Addendum 05

PROJECT: Fort Loramie Local Schools Athletic Complex Building & Associated Improvements
600 East Park Street
Fort Loramie, Ohio 45845

PROJECT #: 25041.00

This addendum form is a part of the Contract Documents and modifies the Bidding Documents dated December 11, 2025 with amendments and additions noted below.

SHEET NUMBER:
A8.1

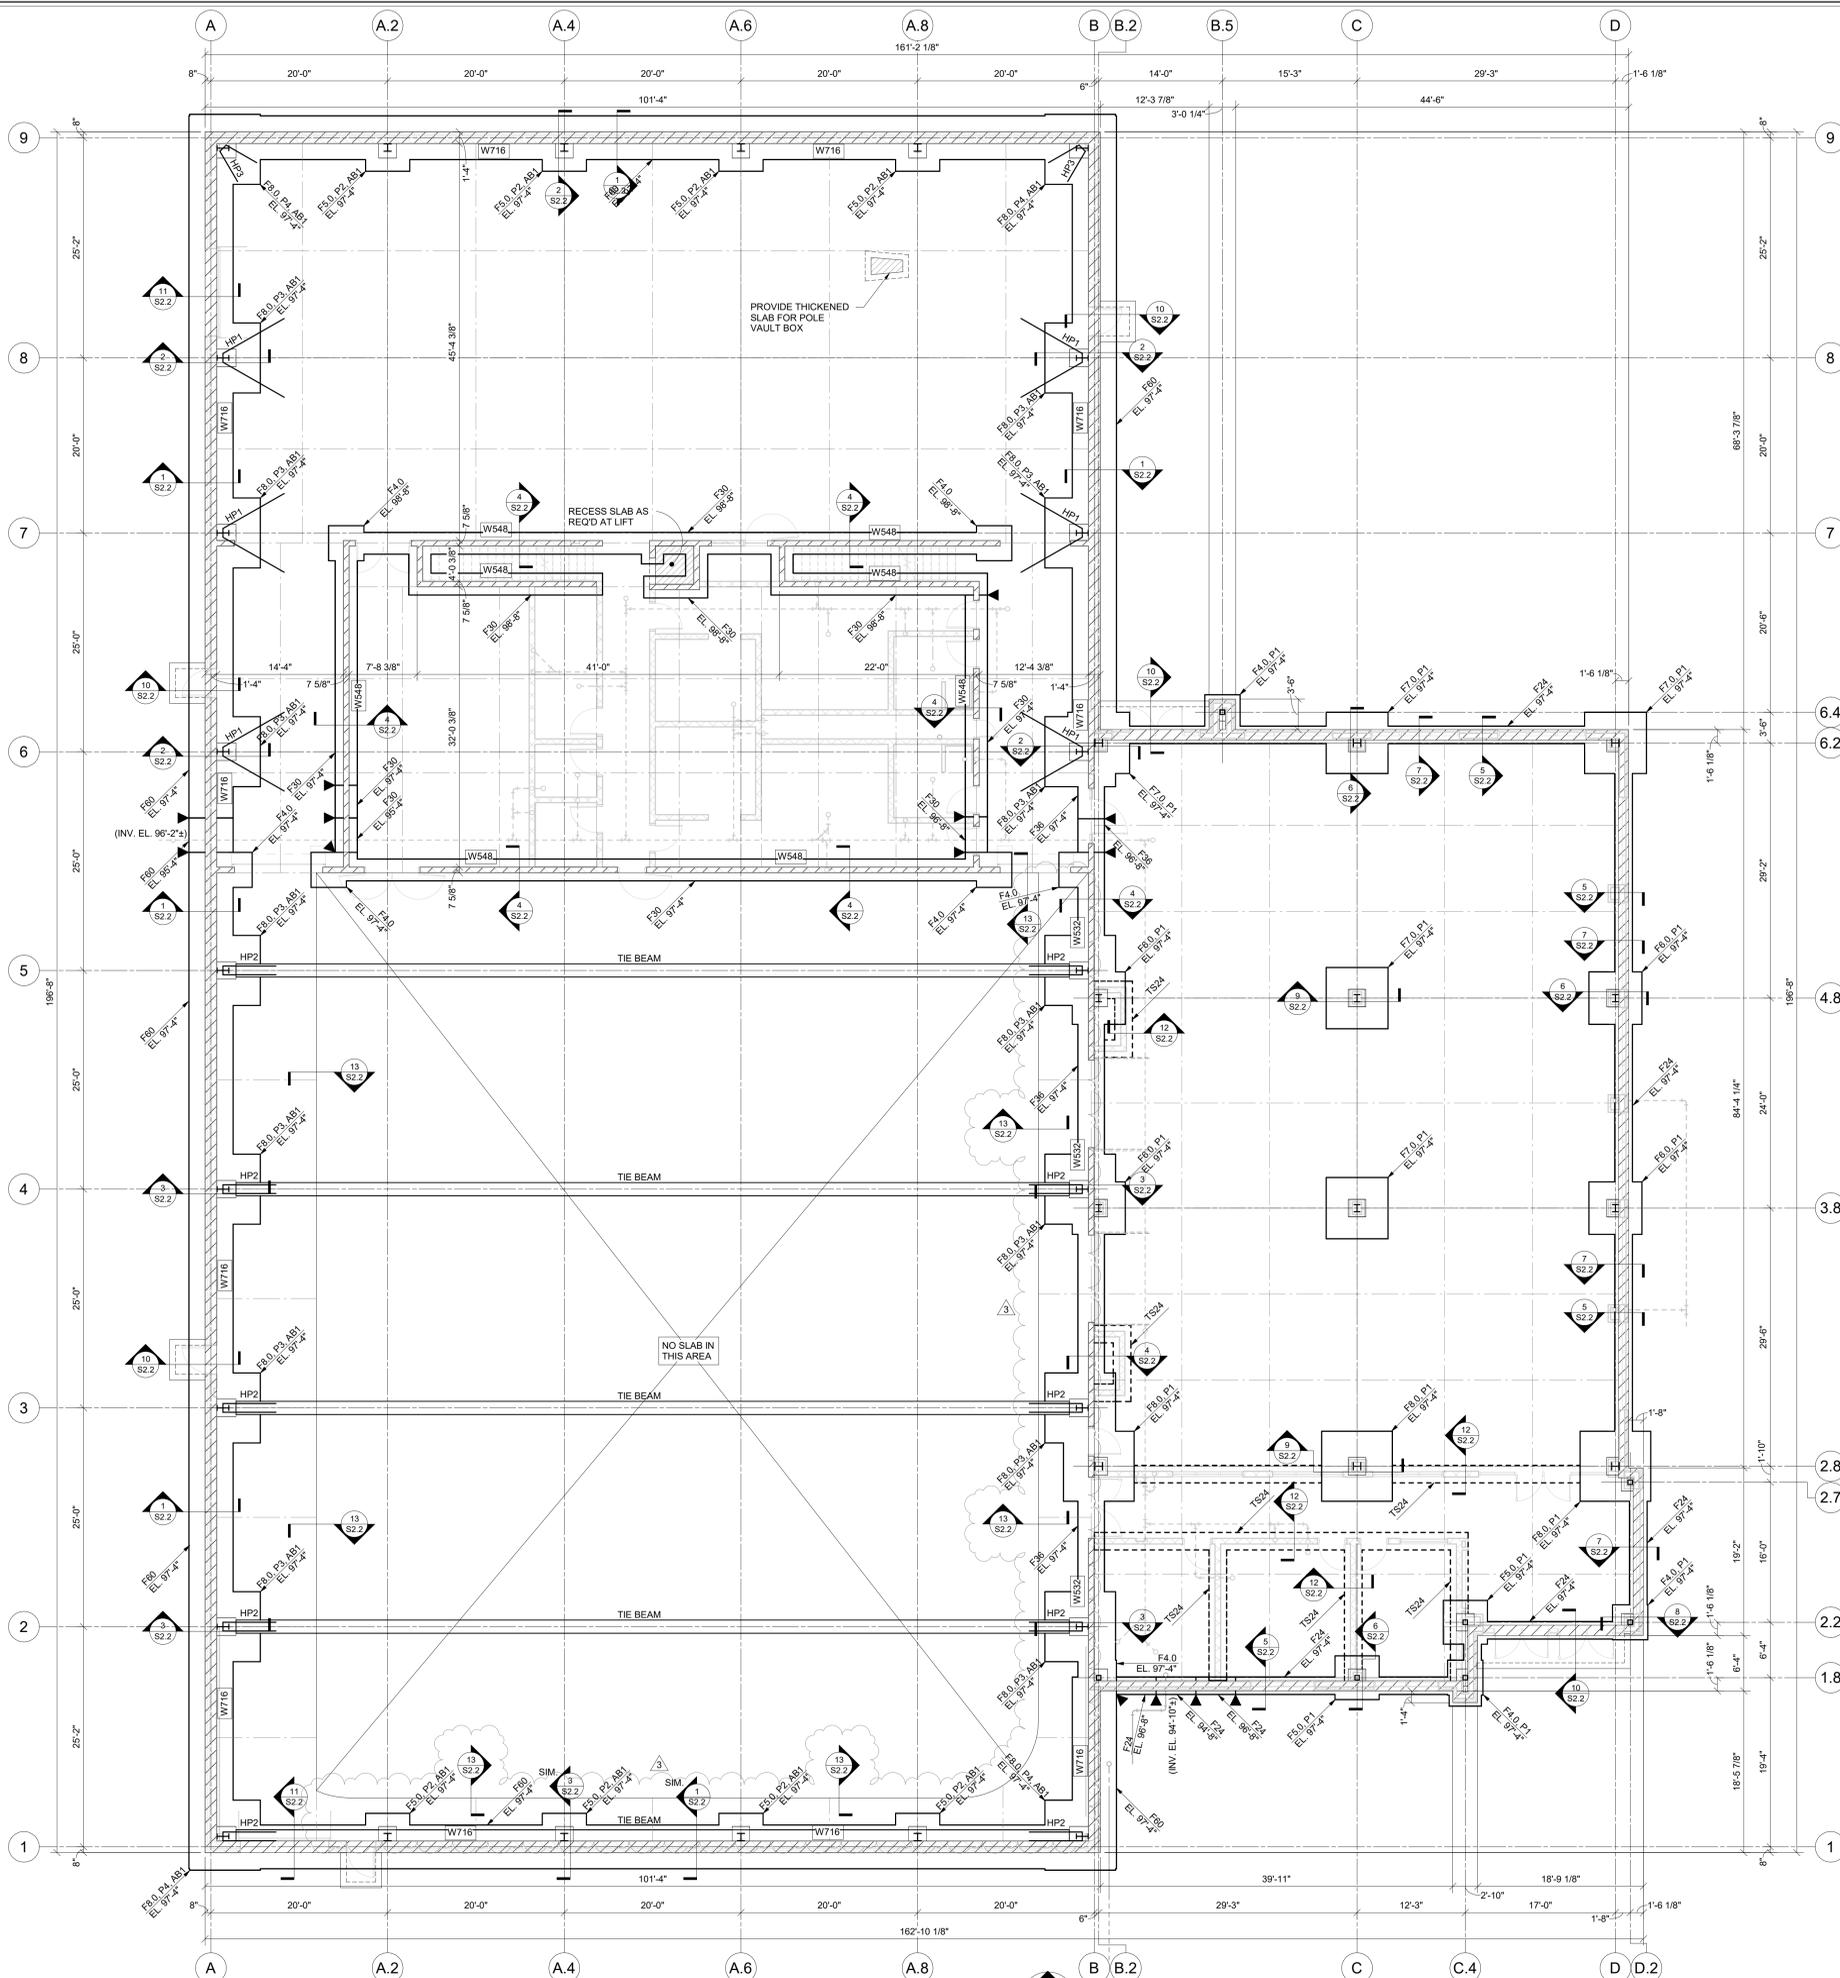
- a. Added furring to walls with liner panel and metal stud.
7. Sheet A8.1 – First Floor Equipment Plan
 - a. Remove metal shelving schedule
 - b. Revised Equipment schedule to show E01 and E04 to be provided by contractor.

10. There is a Metal Shelving Schedule on A8.1 with M01 listed. There are no M01's shown on the drawings. Please Advise No metal shelving in project.
 - a. **Response: Schedule removed from A8.1 in addendum 05**

11. Equipment Schedule on A8.1 does not designate whether the Cube Ice machine and the projection screen are to be provided by the owner or contractor. Please Advise.
 - a. **Response: Both are provided by contractor**

SHEET NUMBER:
S1.1

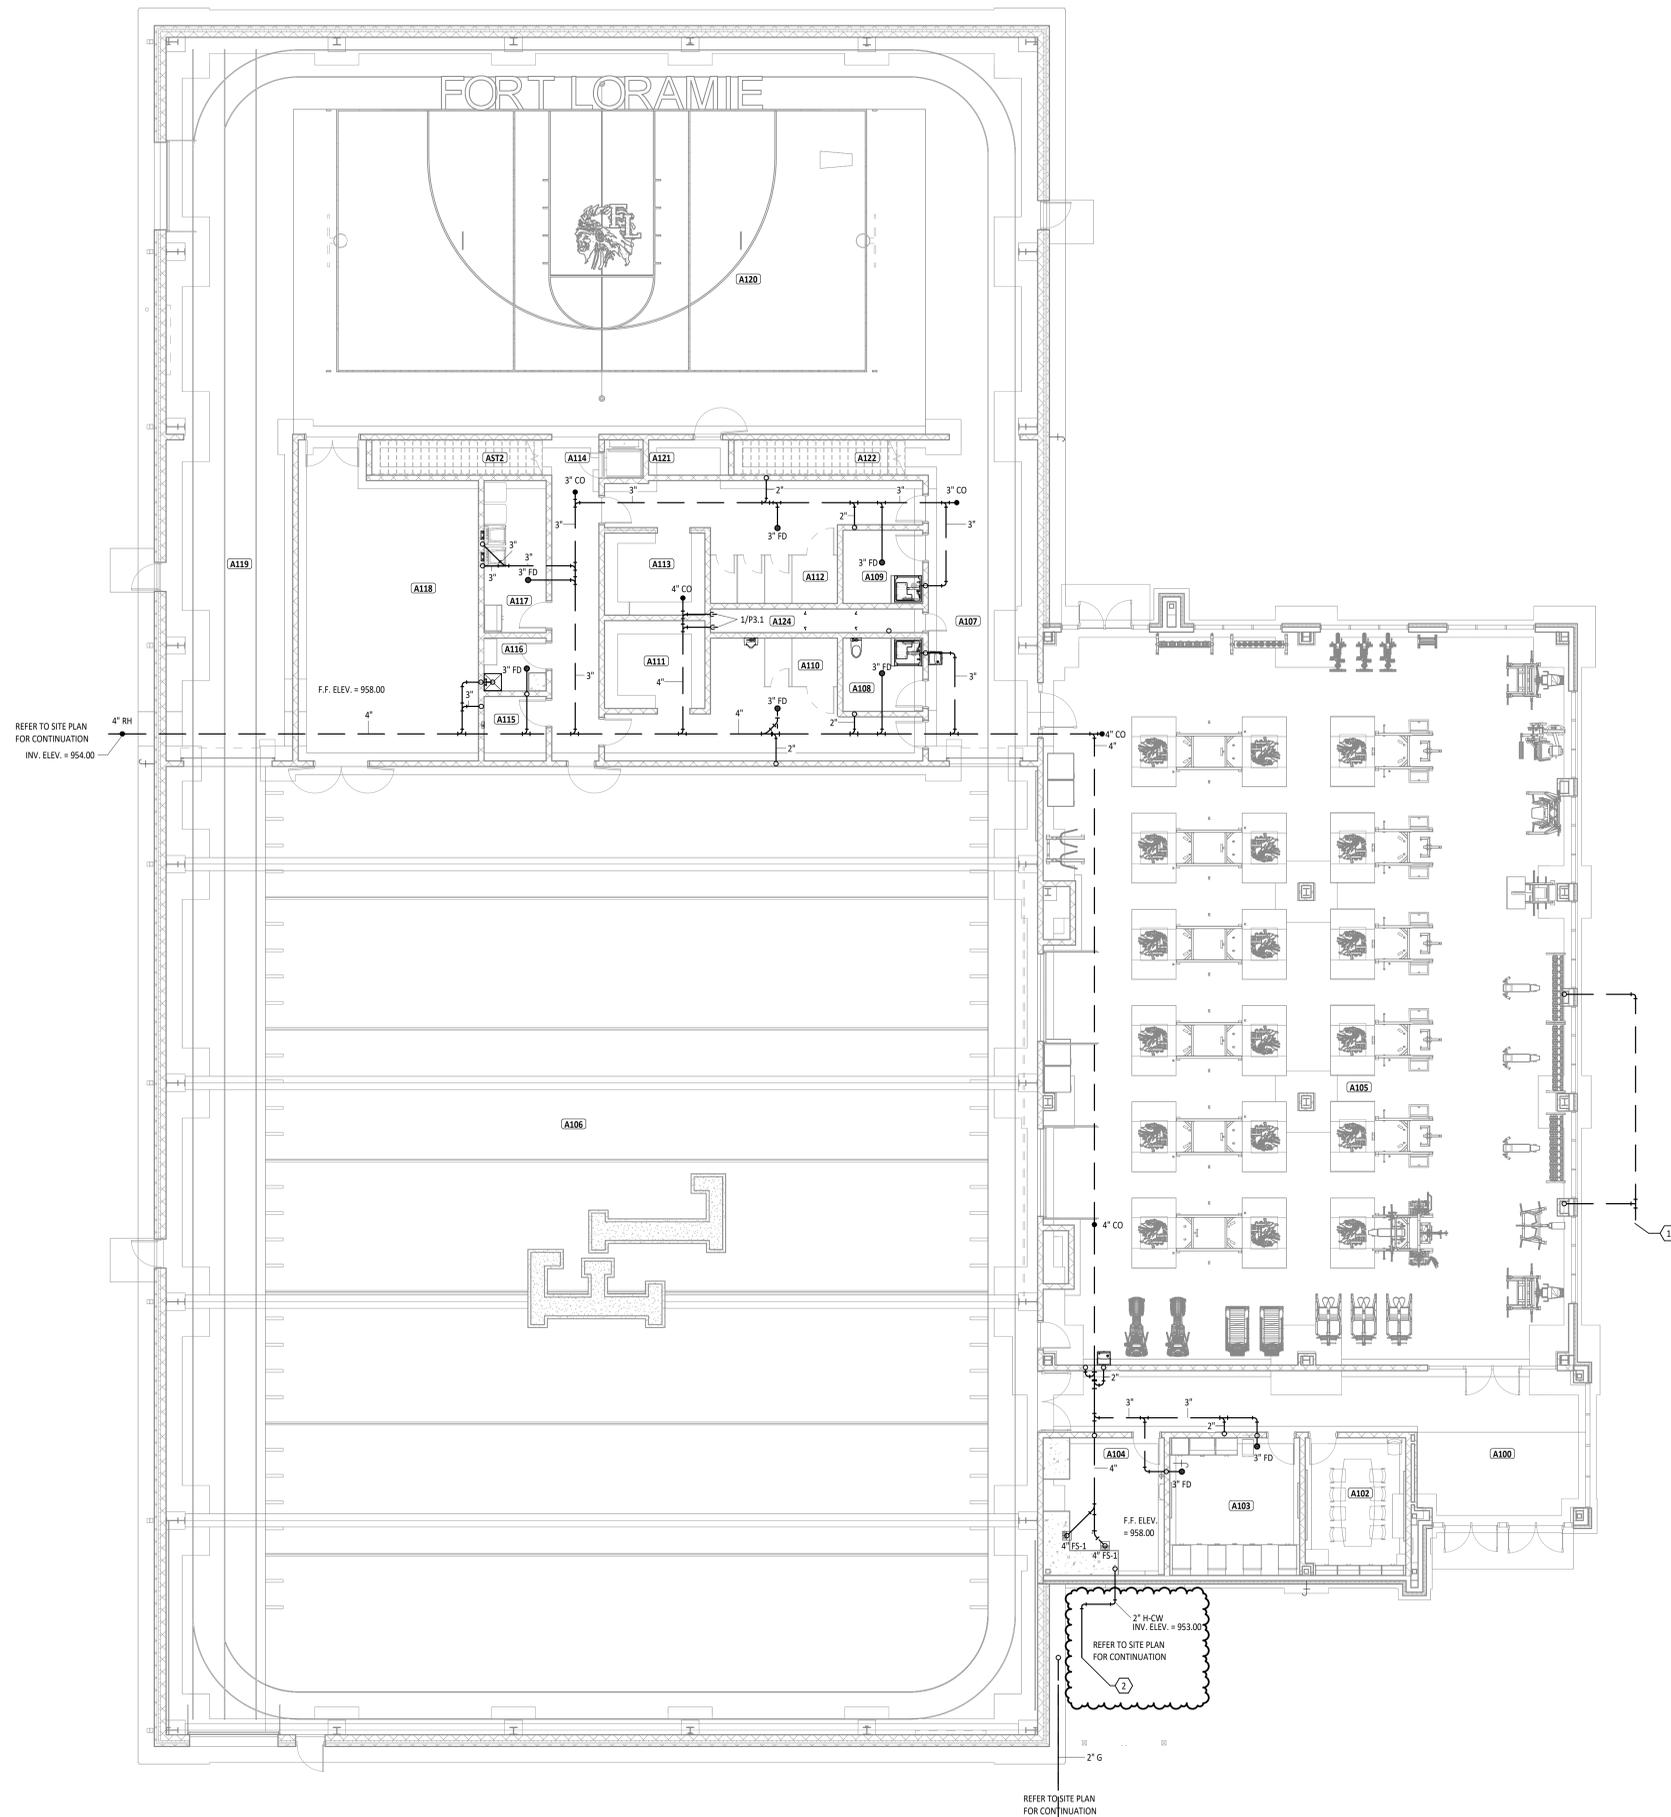
8. Sheet S1.1 – Foundation Plan
 - a. Added slab-on-grade along grids 1 and B
9. Sheet P2.1 – Under -Slab Plumbing Plan – Unit A:
 - a. Added keynote # 2 – “ROUTE WATER MAIN TO AVOID RUNNING UNDER ELECTRICAL TRANSFORMER. COORDINATE WITH ELECTRICAL AND SITE CONTRACTORS.”

6. Detail 4/S2.2 shows concrete slab on grade on both sides of the CMU wall. On sheet S1.1, it appears there is to be no slab on the south side of the north wall and west side of the east wall in room A106. The same is true of cut 1/S2.2 shown on the south exterior wall in room A106 on sheet S1.1 between column lines A.4/A.6. Please confirm the only slab on grade in room A106 is the 11'-3" wide section running north/south along the west exterior wall in room A106. Also, please confirm the 1'-6" x 8" concrete tie beams shown in detail 3/S2.2 only run east/west at column lines 2, 3, 4, and 5, as cut 3/S2.2 is also shown on the south wall of room A106 on sheet S1.1, specifically at column line A.4 with the words TIE BEAM between column lines A.4/A.6 on column line 1. Also, please confirm the base material that fills in between the tie beams. Stone by the turf contractor on earth? Also, please confirm footings F5.0 west of column line B are correctly depicted as a 5'x5' spread footing does not reach the backside of the continuous footings at these locations on the two endwalls.

- a. **Response:**
 - b. **1) A portion of slab is to remain around the perimeter of Room A106 below the track running lanes. The foundation plan will be updated in Addendum 05 to address this.**

SHEET NUMBER:
M2.1

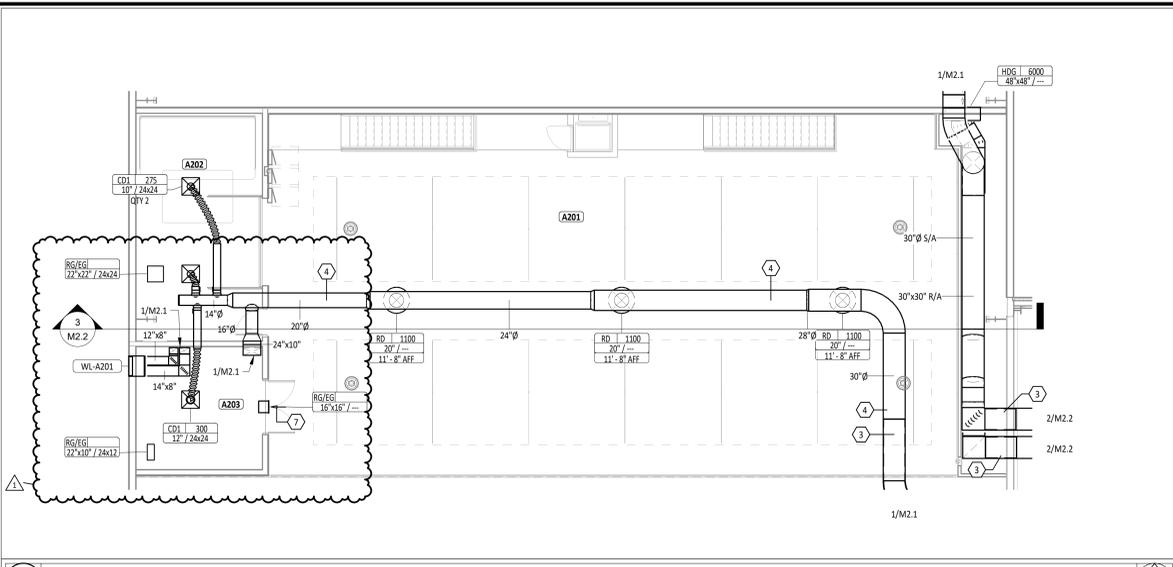
10. Sheet M2.1 – Mechanical Plan – First Floor
 - a. Change main trunk duct from fabric to metal ductwork. The location of the transition from metal to fabric has change with fittings to change elevation. Fabric duct now slopes with roof. Refer to updated sheet.

- b. Add Section 10/M5.1 to view.
 - c. Add air transfer openings and grilles as shown on updated sheet.
 - d. Add Keynote #10.
11. Sheet M2.2 – Mechanical Plan – Mezzanine, Roof Plan, and Schedules

SHEET TITLE: MECHANICAL PLAN - MEZZANINE, ROOF PLAN, AND SCHEDULES
SHEET NUMBER: M2.2

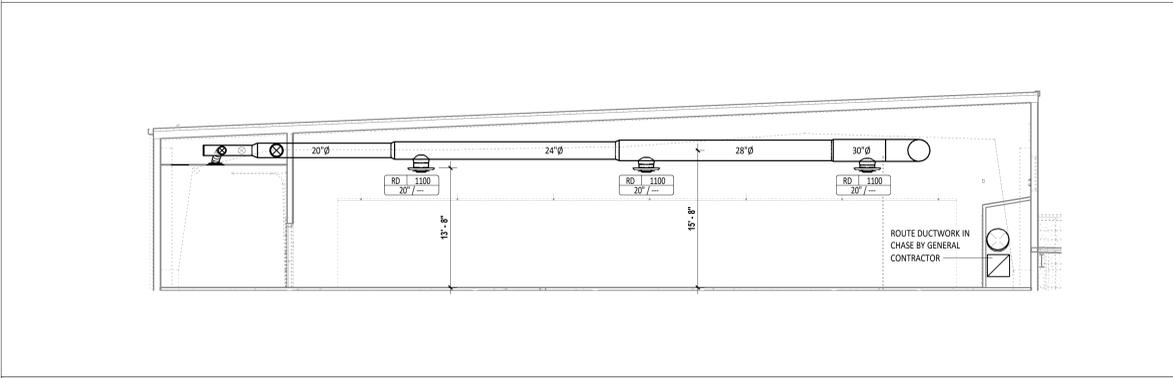
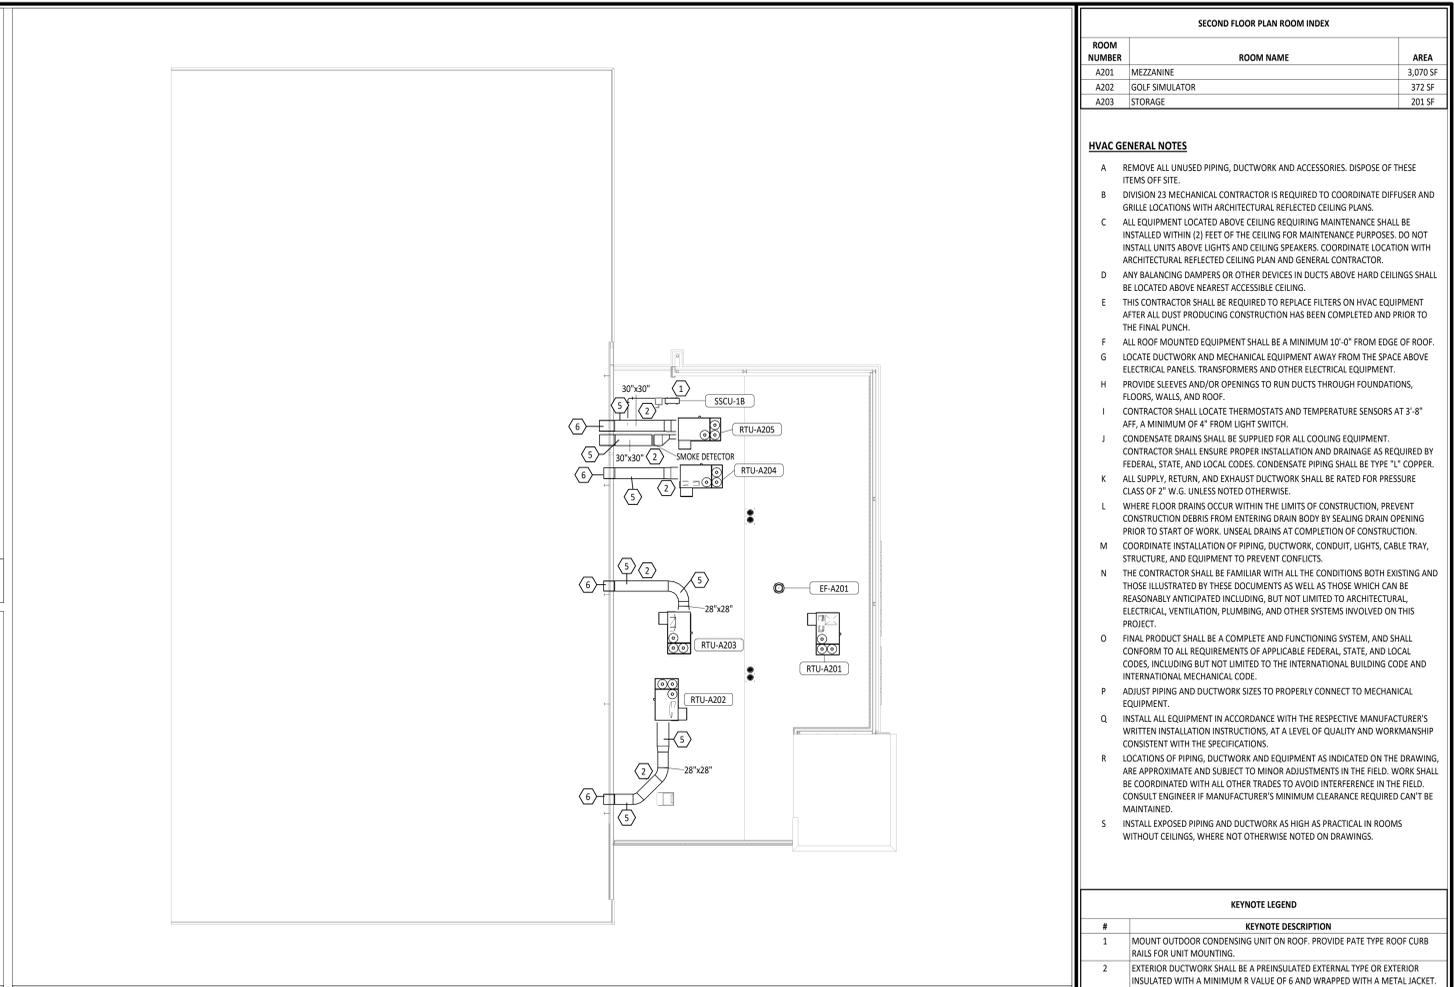
- a. Add air transfer openings and grilles as shown on updated sheet.
 - b. Add Keynote #7.
 - c. Modify supply airflow value for RTU-A204 as shown on updated sheet.
